FOREST LAKES FILING NO. 6

CONSTRUCTION PLANS

EPC STORMWATER REVIEW COMMENTS
IN ORANGE BOXES WITH BLACK TEXT

FOREST LAKES FILING NO. 6 CONSTRUCTION PLANS TITLE SHEET			
DESIGNED BY	MAL	SCALE	DATE 08/04/2020
DRAWN BY	MES	(H) 1" = N/A	SHEET 1 OF 25
CHECKED BY		(V) 1" = N/A	JOB NO. 1175.60

FOREST LAKES FILING NO. 6 PUBLIC STREET IMPROVEMENT PLAN

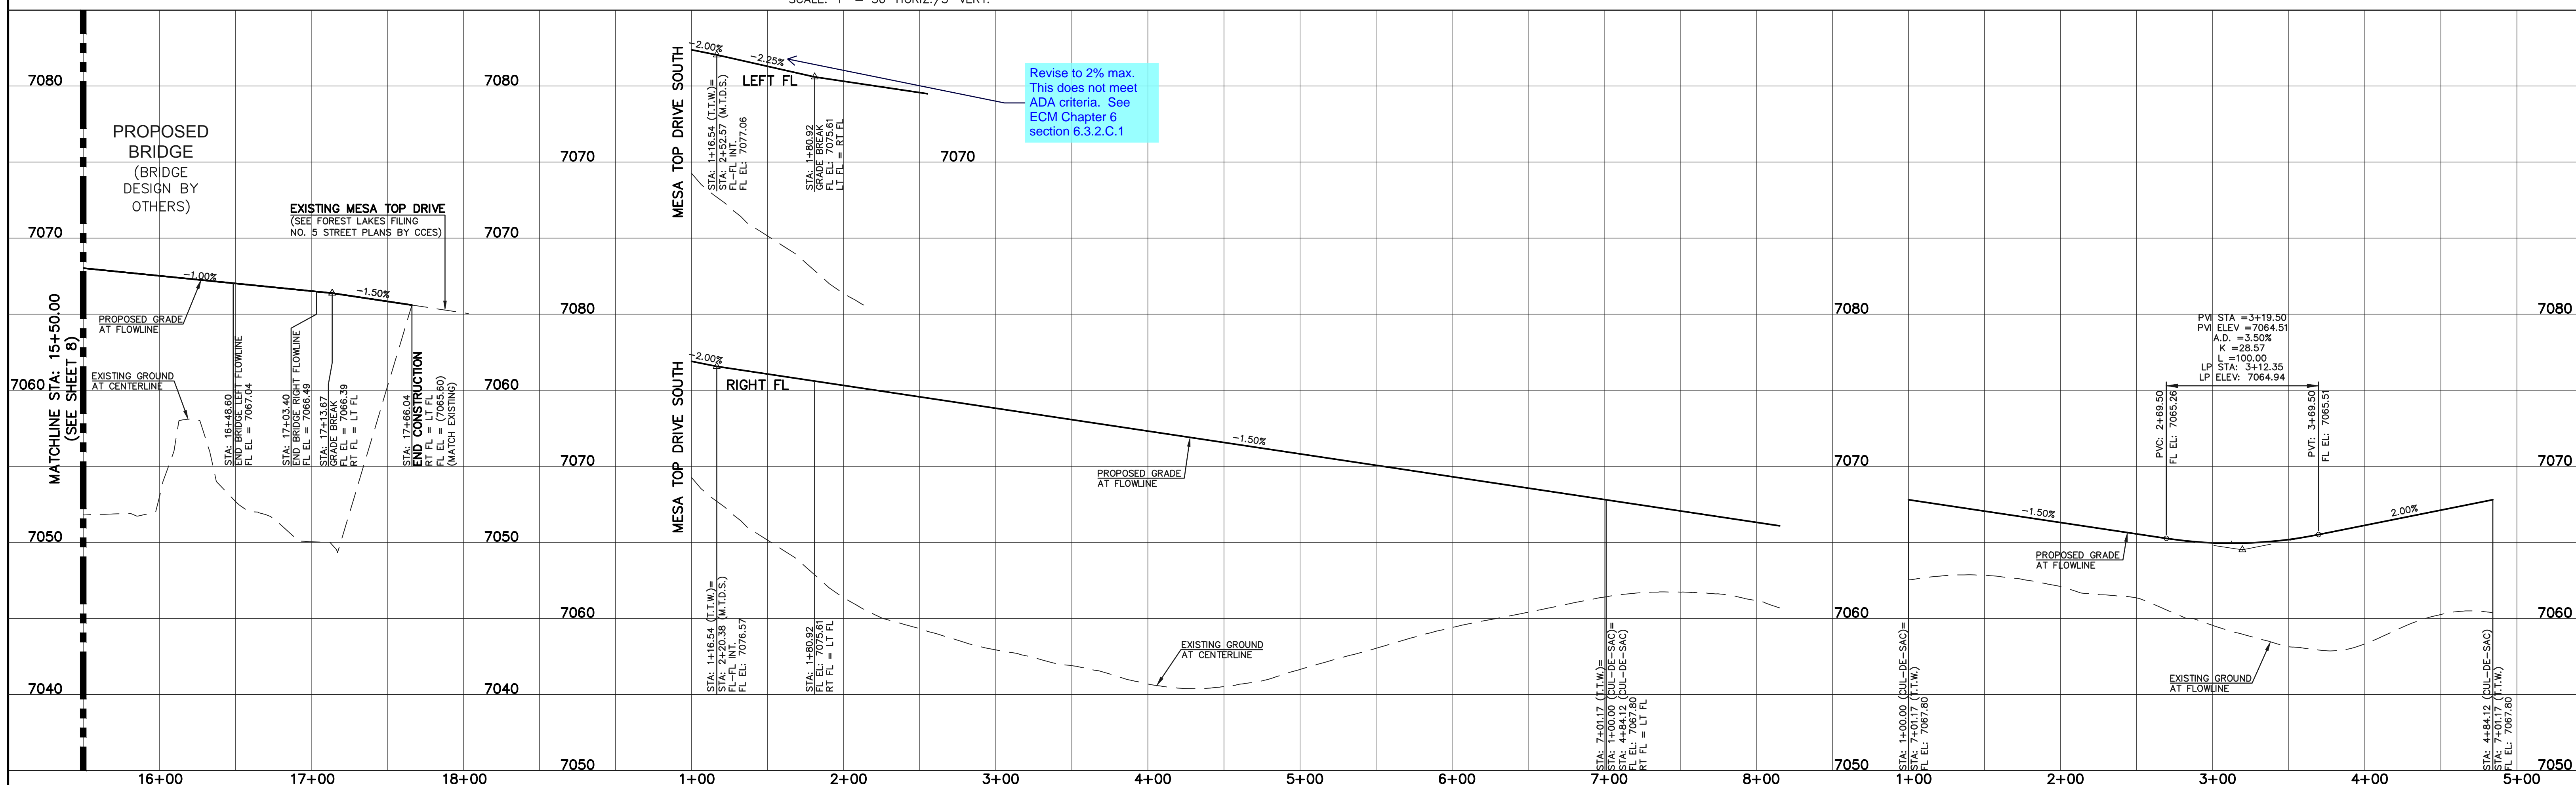
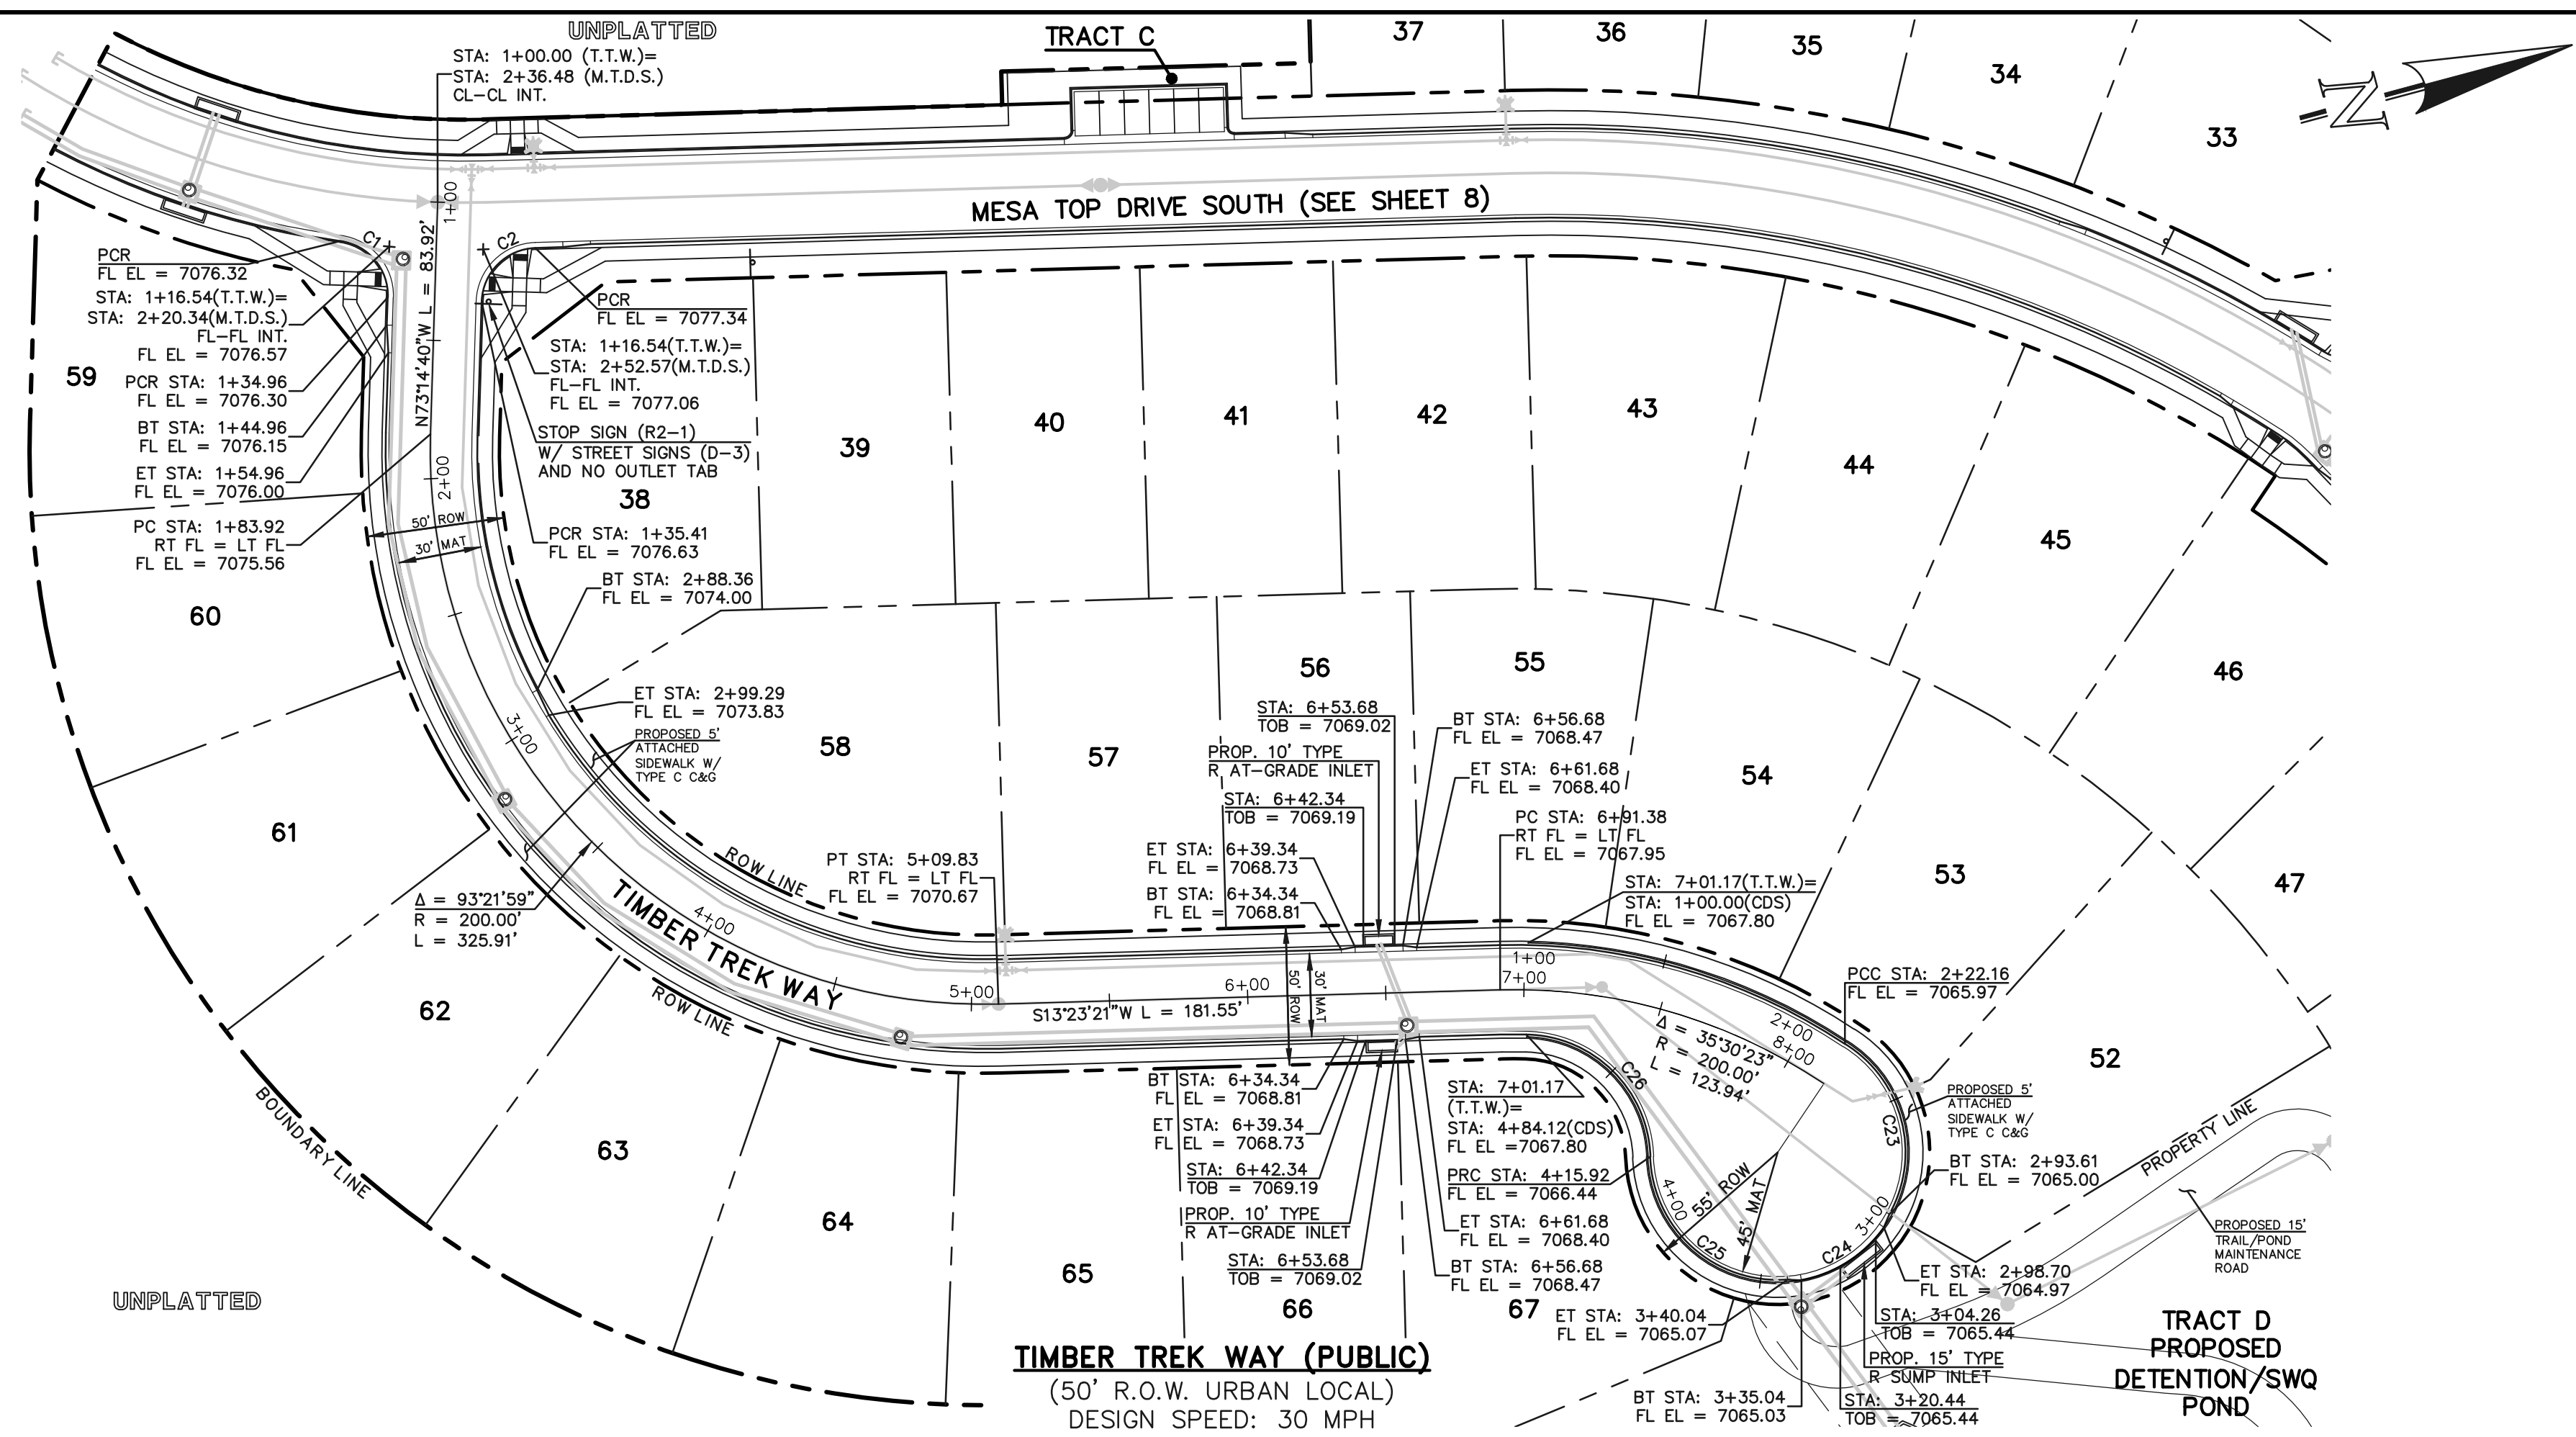
Provide Plan/Profile of the combined emergency access/trail. Based on the cross section detail on the preliminary plan this should be wider.

Revise to 2% max. This does not meet ADA criteria. See ECM Chapter 6 section 6.3.2.C.1

Show the temporary turnaround easement.
Provide the cul-de-sac design.
Adjust the riprap rundown location.

FOREST LAKES FILING NO. 6
PUBLIC STREET IMPROVEMENT PLAN
 MESA TOP DRIVE NORTH
 STA. 9+00.00 - END

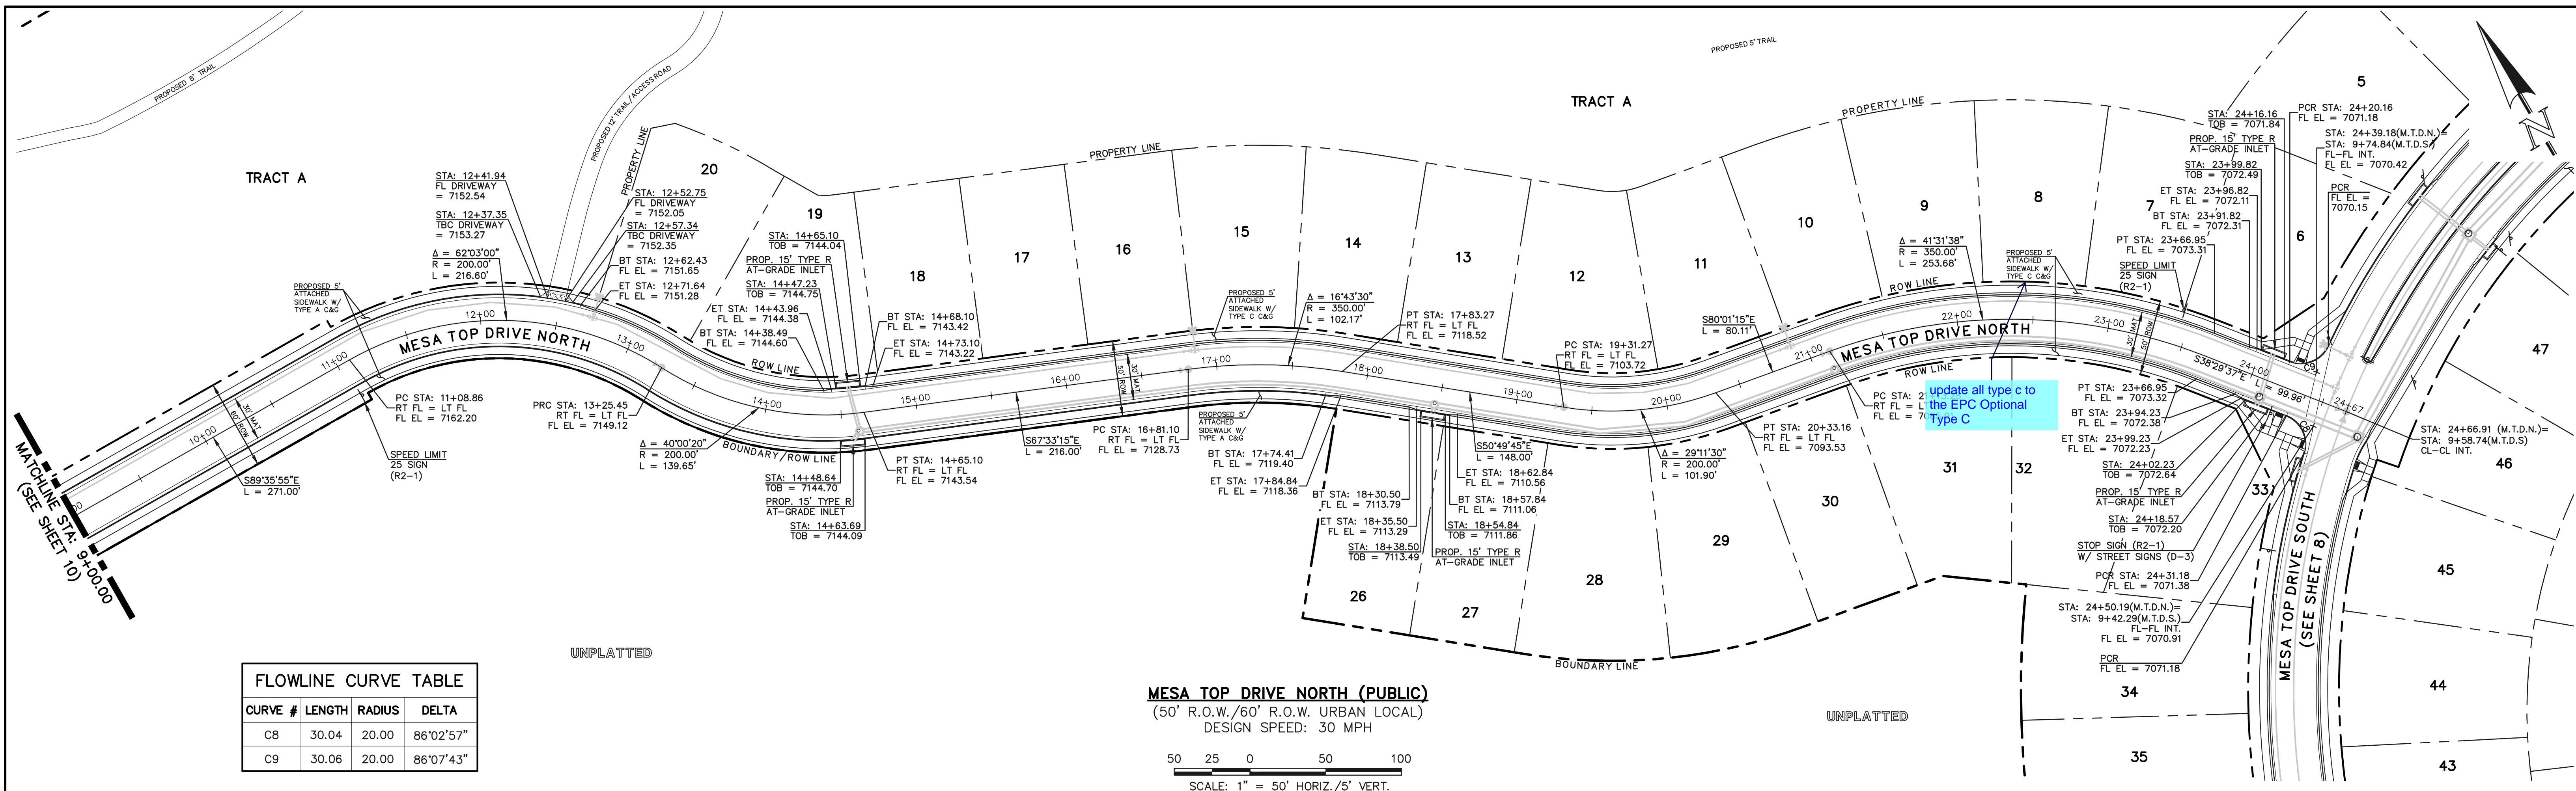
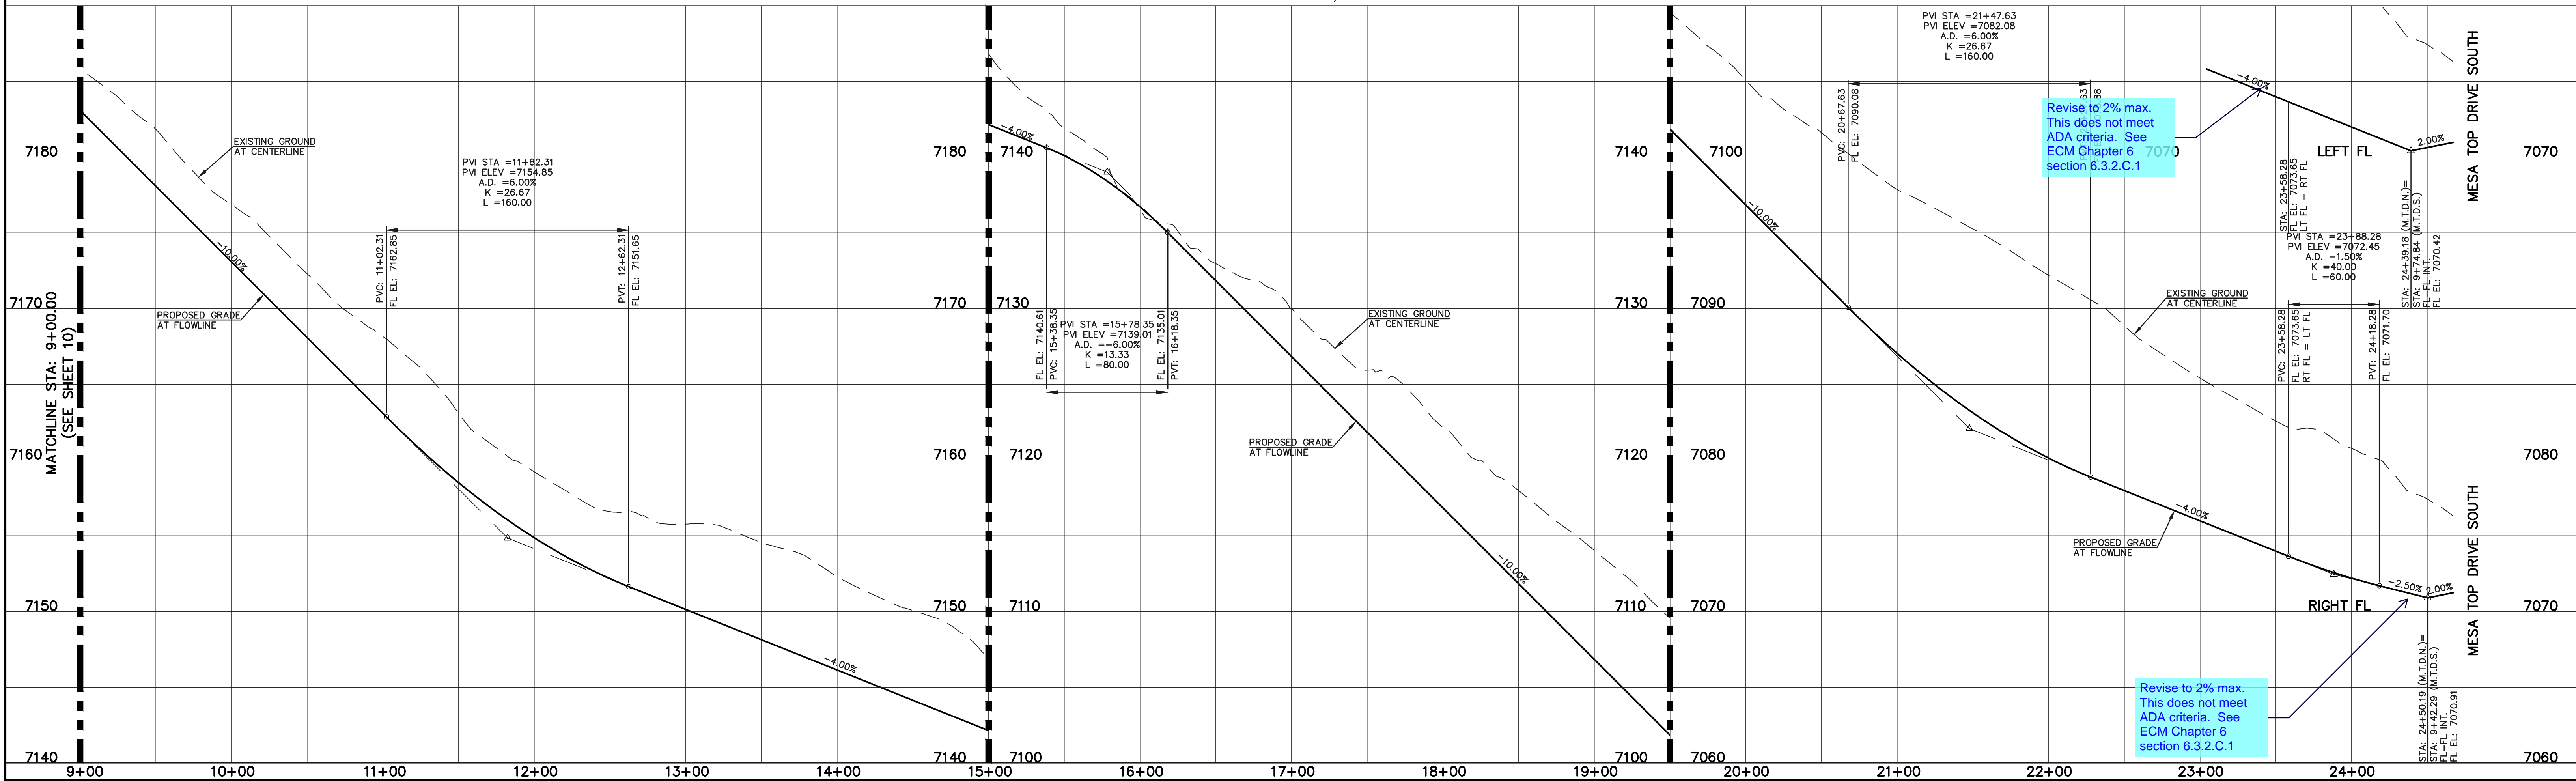
Revise to 2% max. This does not meet ADA criteria. See ECM Chapter 6 section 6.3.2.C.1

Revise to 2% max. This does not meet ADA criteria. See ECM Chapter 6 section 6.3.2.C.1
